Re: SHPO Project Number: 18PR07273 (For Generic), 21PR04693 (Supplemental)  
National Historic Preservation Act (NHPA) – Section 106 Consultation  
Albany Port District Commission Port of Albany Expansion Project  
Beacon Island Property

**Project Name:** ENV#2642101 309 River Rd

**Subject:** Site Plan Review Comments received 11/17/2021

Re: Port of Albany Marmen-Welcon Manufacturing Facility: 309 River Road Fire Flow

DRAWING TITLE  
**SITE PLAN OVERALL**

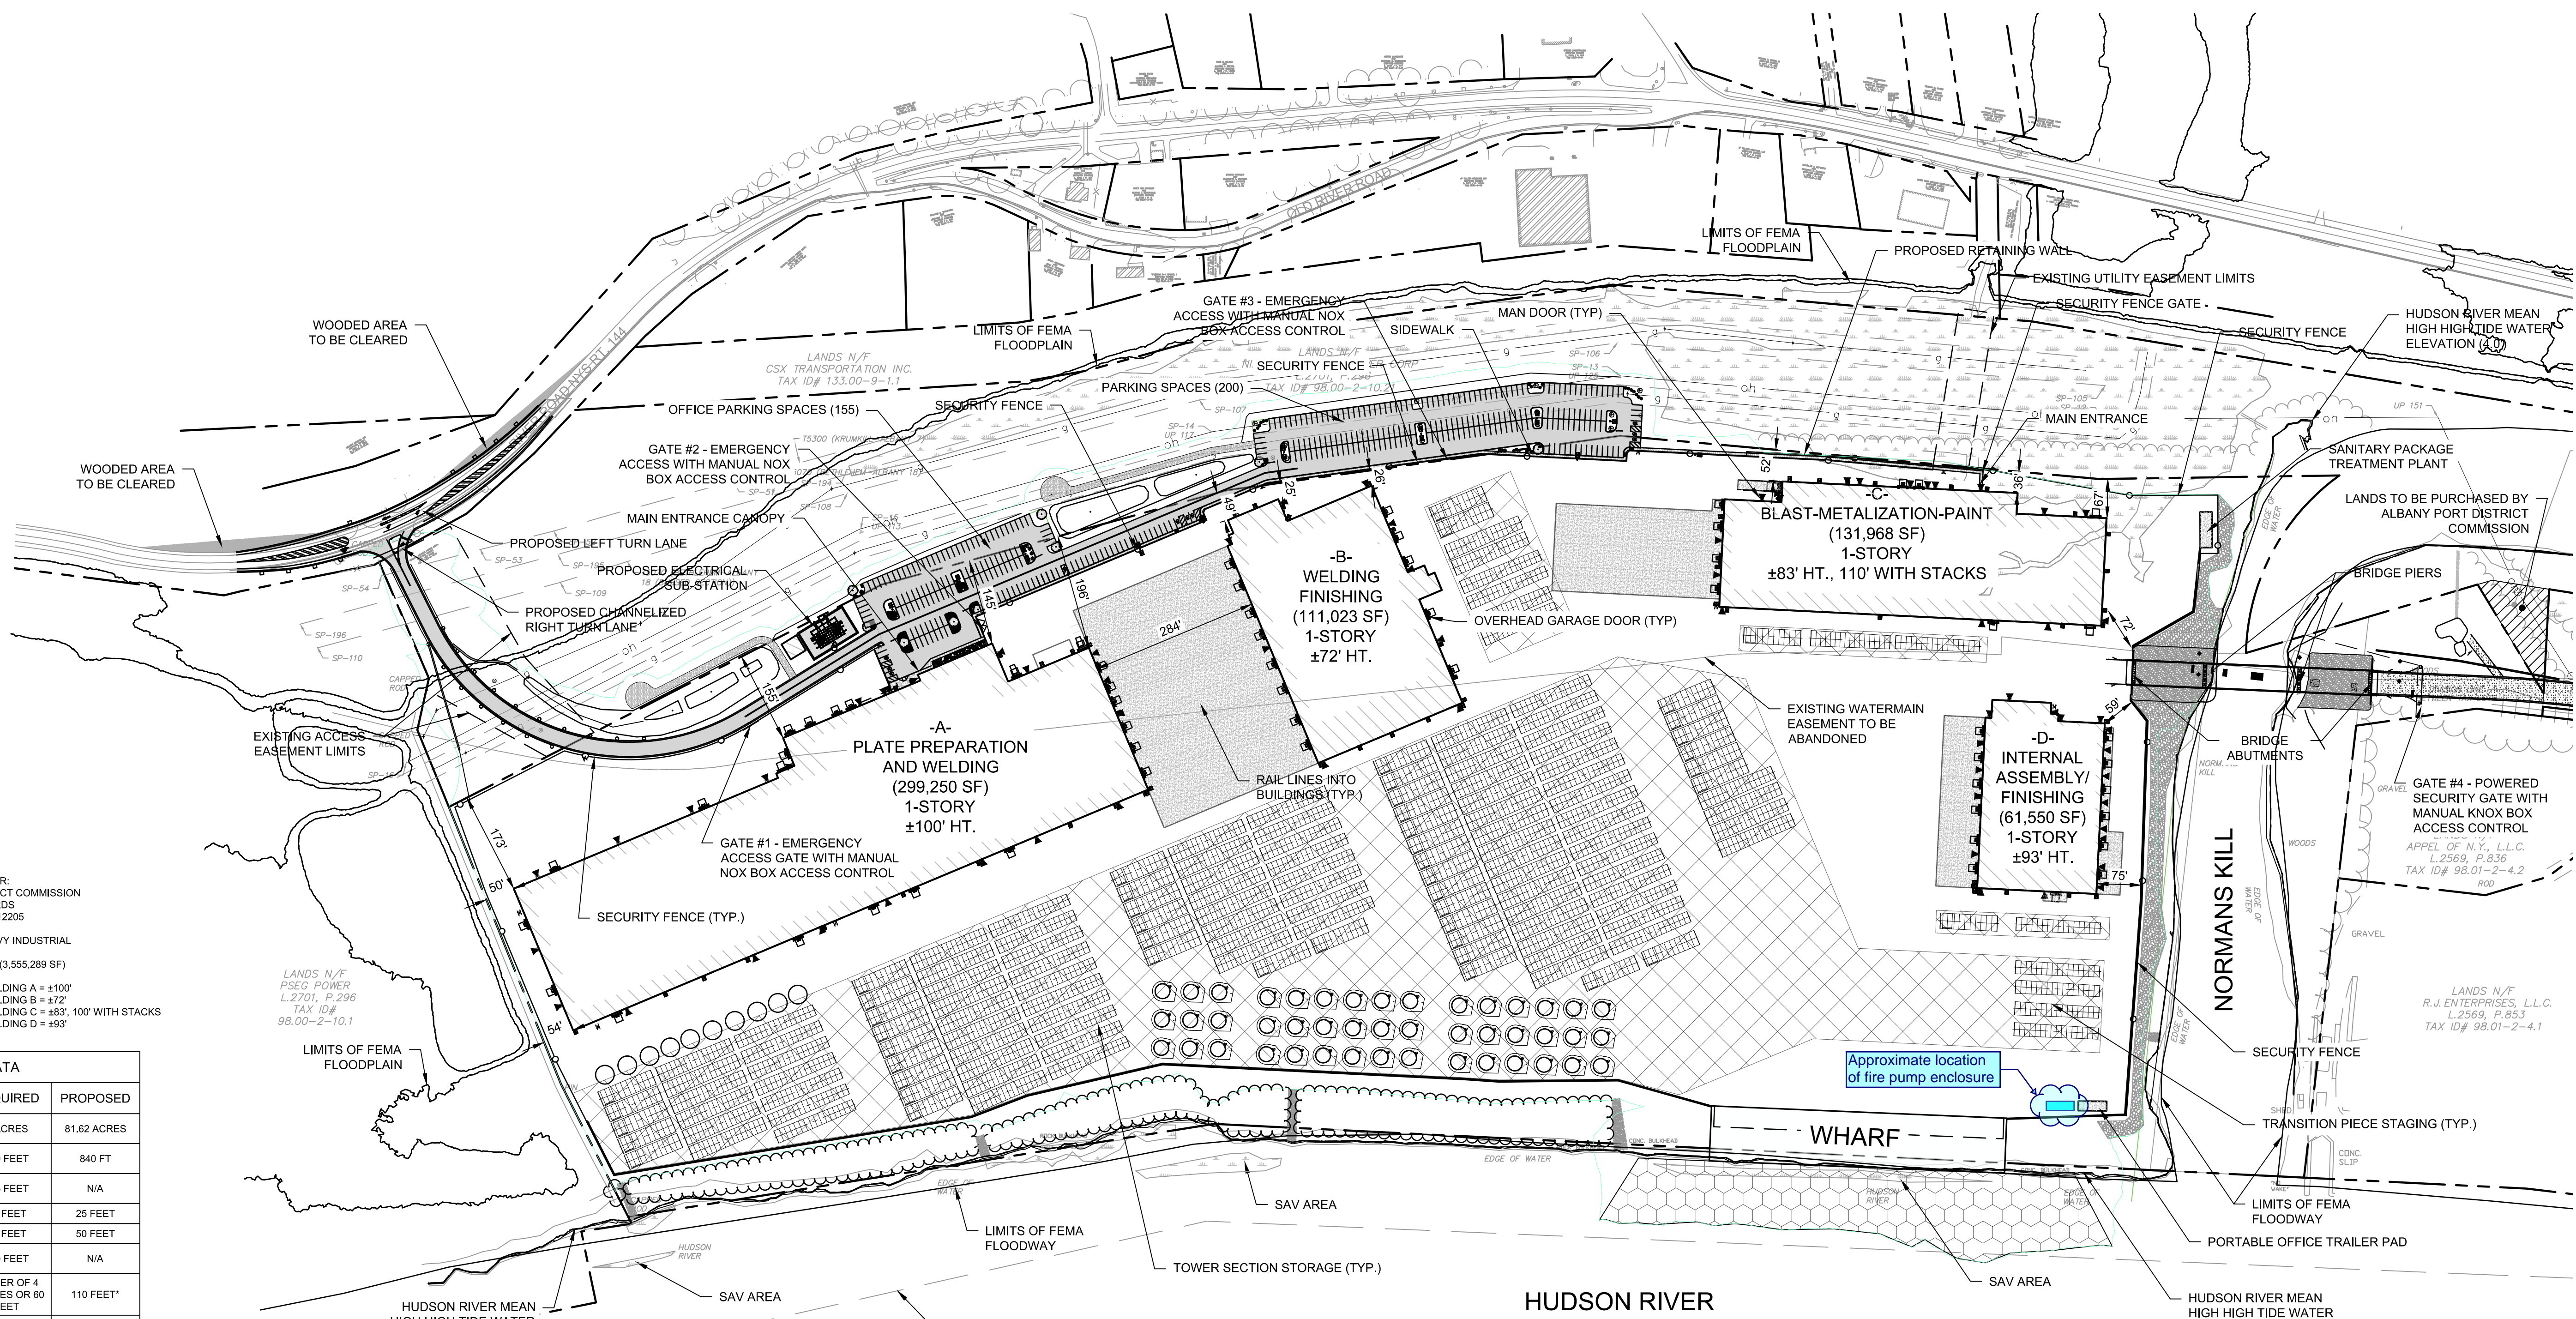
- Fire Code, Chapter 5 and Appendix D, requires Fire Apparatus Access roads and Aerial Fire Apparatus Access roads. The applicant needs to provide a site plan delineating the Code compliant Fire Access into the site and around each building on the site.

- Emergency access into the site is limited. The only gate access shown from Rt 144 entrance is obstructed by parking spaces and islands. This needs to be rearranged to provide easy maneuvering through the gate.
  - **Please see accompanying overall site plan titled “Fire Code Plan”. Additional emergency access gates equipped with Knox Boxes are now located on this plan to allow adequate Fire Department access around each building as highlighted in green.**

- Additional Fire apparatus access road with gates are requested. One on the road in from Rt 144 entering near the south side of building A and another from the parking area in between Buildings C & D
  - **Please see accompanying overall site plan titled “Fire Code Plan” indicating the newly located emergency access gates with Knox Boxes.**

- **Please see accompanying overall site plan titled "Fire Code Plan". The green line on this plan indicates a 25' wide, 360-degree access for each building as well as a detailed truck turn template for aerial fire trucks. All surfaces surrounding each building of this project will be comprised of dense graded aggregate with loading capacity to allow movement of extremely heavy equipment loads around the site associated with the manufacturing operations. This Fire Access pathway has been confirmed with Operations for the facility and will have adequate capacity to support the fire service vehicles. All fire accessways will be designated with signage posted at regular intervals around each building.**
